STAFF RECOMMENDATION 1101 McKennie Avenue December 16, 2020

Application: New Construction – Addition; Setback Determination
District: Eastwood Neighborhood Conservation Zoning Overlay
Council District: 06
Base Zoning: MUG-A
Map and Parcel Number: 072130421
Applicant: David Brawner, Pfeffer Torode
Project Lead: Jenny Warren, jenny.warren@nashville.gov

<p>Description of Project: Application for the construction of an addition, requiring a rear setback determination.</p> <p>Recommendation Summary: Staff recommends approval with the following conditions:</p> <ol style="list-style-type: none">1. A pedestrian connection to the sidewalk at Gallatin Road shall be provided;2. Staff shall approve the windows and doors prior to purchase and installation; and,3. The HVAC shall be located on the rear façade, beyond the midpoint or on the interior side façade, <p>finding that the project meets Section II.B of the <i>Eastwood Neighborhood Conservation District: Handbook and Design Guidelines</i>.</p>	<p>Attachments A: Photographs B: Site Plan C: Elevations</p>
---	--

Figure 3: Roof plan showing proposed additions

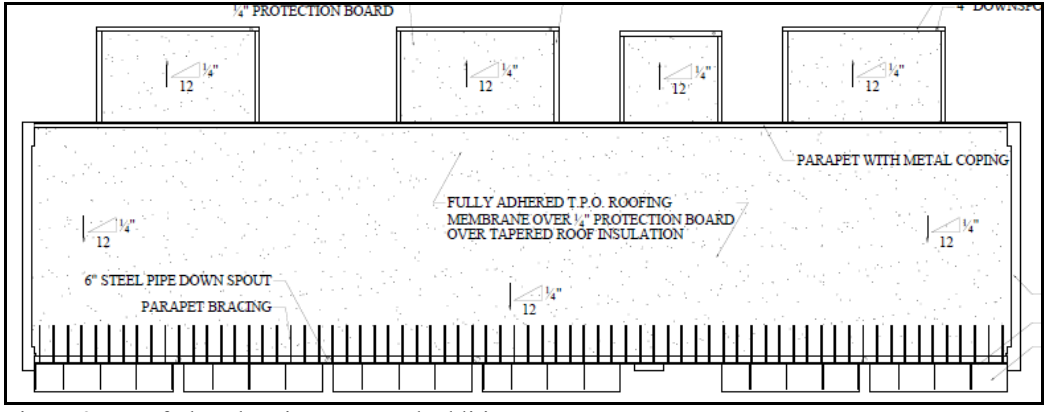
The existing structure is about fourteen feet (14') tall. The height will not be increased. The additions will be about nine feet (9') in height.

The four rear additions will be inset from the side walls and will measure about ten feet (10') in depth by sixteen feet (16') in width. The second one from McKennie will be smaller at about ten feet (10') by ten feet (10'). The additions meet the section II.B.1.a. and b for height and scale.

Figure 4: Proposed cladding material

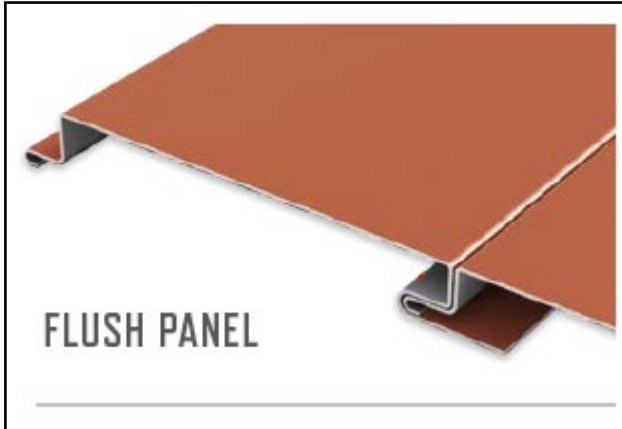
Stucco and aluminum wall cladding are the primary materials. The proposed aluminum siding is a flush panel system with thin joints. Not all of the proposed materials would be appropriate for an addition to a historic building elsewhere in the overlay, but staff finds that they are appropriate for a non-contributing commercial structure in this location facing Gallatin Road. With the condition that staff review and approve the doors and windows prior to purchase and installation, staff finds that project meets section II.B.1.d

Figure 6: The highlighted area is recommended for a stair to connect to the sidewalk as it is the area of lowest grade that will not interfere with the proposed parking area or green wall.

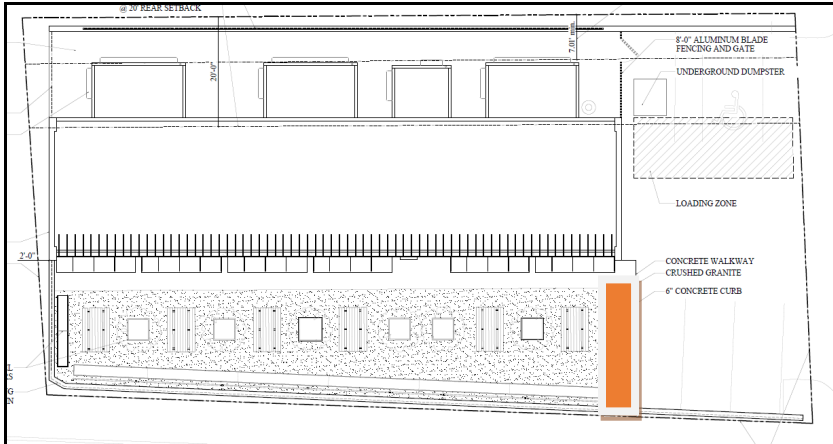
Orientation: The proposed green wall will visually disconnect the front of the building from the street; which is typically not appropriate in a historic district. In this case, the site is already disconnected by a tall retaining wall, which will remain. Staff

recommends a stair from the sidewalk to the development's walkway to create a connection to the sidewalk as typically seen in historic districts; otherwise, the only pedestrian connection is through the parking area. The parking design/location will be reviewed by Public Works. With the condition that there is a pedestrian connection to the sidewalk the project meets section II.B.1.f.

1. A pedestrian connection to the sidewalk at Gallatin Road shall be provided;
2. Staff shall approve the windows and doors prior to purchase and installation; and,

Figure 7: Side elevation, facing McKennie Avenue

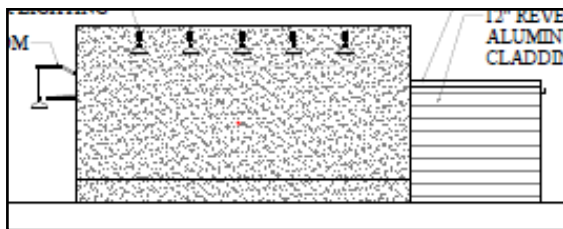
Proportion and Rhythm of Openings: The window and door openings facing Gallatin Road are appropriate for a commercial structure in this location. (Figure 5) The side elevations will have no doors or windows added (Figure 6) and the rear elevation has service doors. Side and rear elevations of commercial structures commonly have few

doors and windows and this is an existing condition. Staff finds the project's proportion and rhythm of openings to be appropriate for this structure in this location. The proposal meets Section II.B.1.g.
